Service Provider Letter

Jurisdiction:	<u>City of Sherwood</u>	Review Type:	<u>Tier 2 Analysis</u>
Site Address	<u>17433 SW Brookman Rd</u>	SPL Issue Date:	<u>May 11, 2020</u>
/ Location:	<u>Sherwood, OR 97140</u>	SPL Expiration Date:	<u>May 11, 2022</u>

Riverside at Cedar Creek Residential Subdivision
(with right-of-way improvements)

Fig. 4

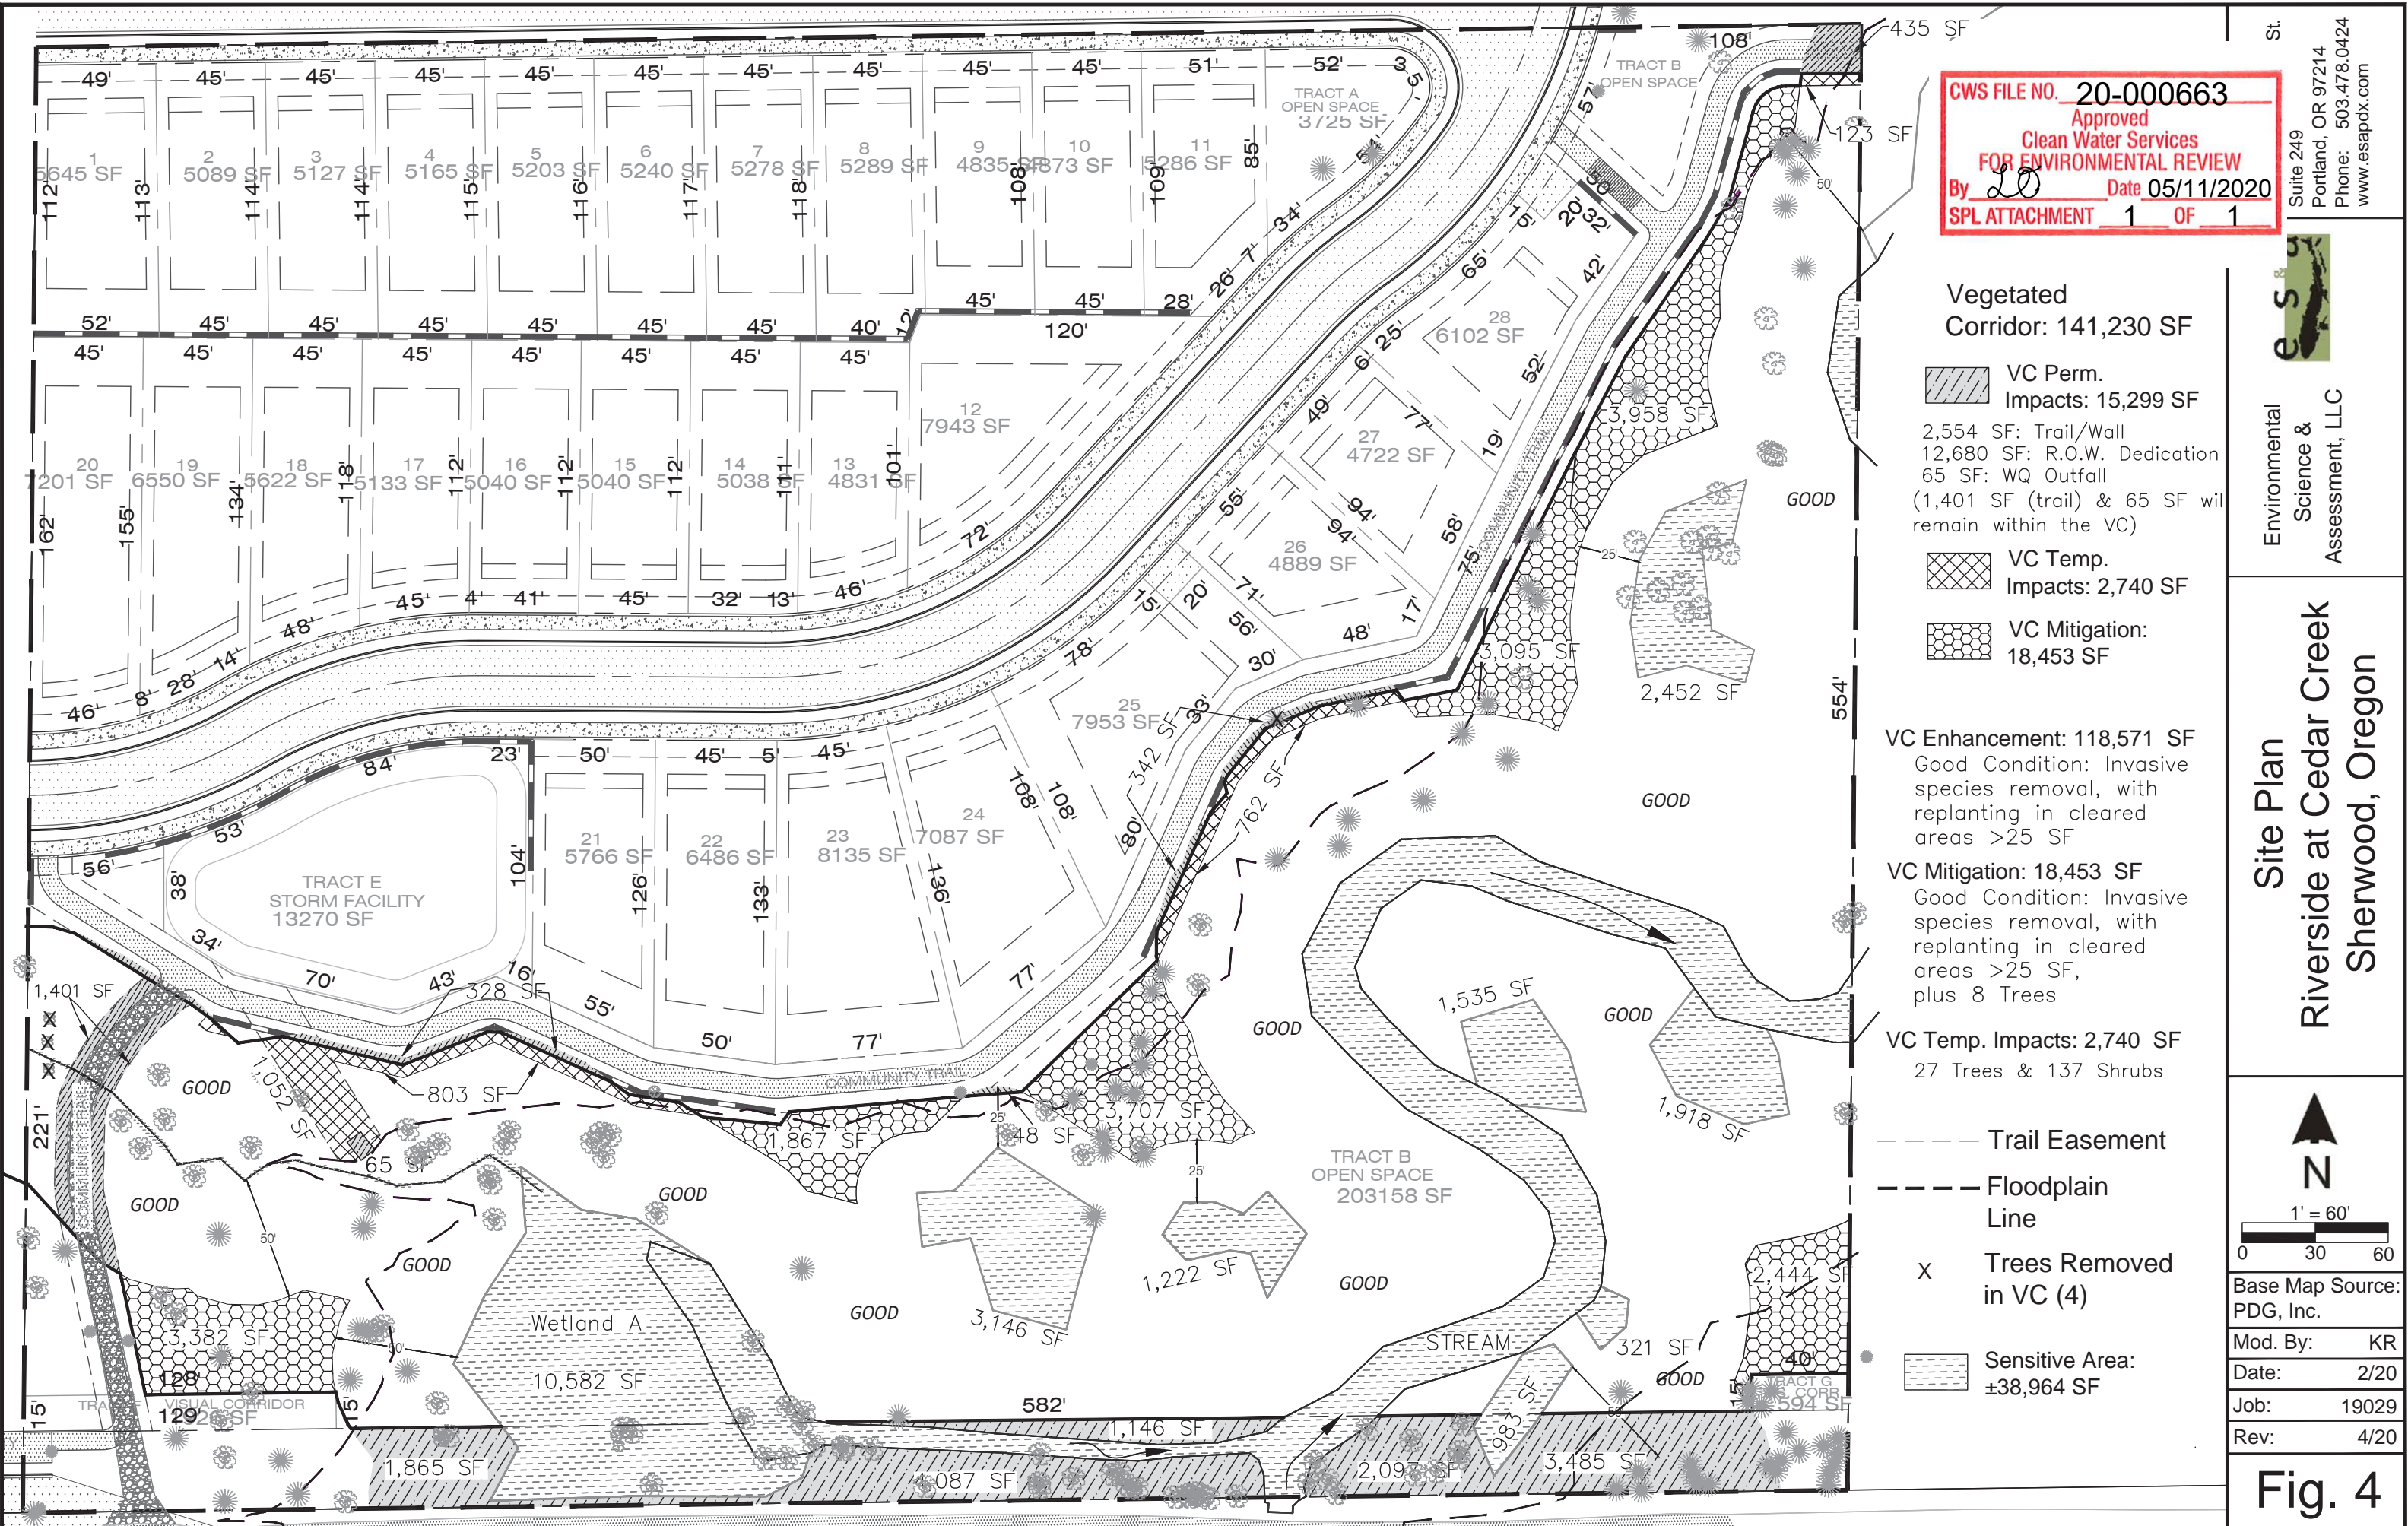
CWS FILE NO. 20-000663
 Approved
Clean Water Services
FOR ENVIRONMENTAL REVIEW
 By *LO* Date **05/11/2020**
SPL ATTACHMENT 1 OF 1
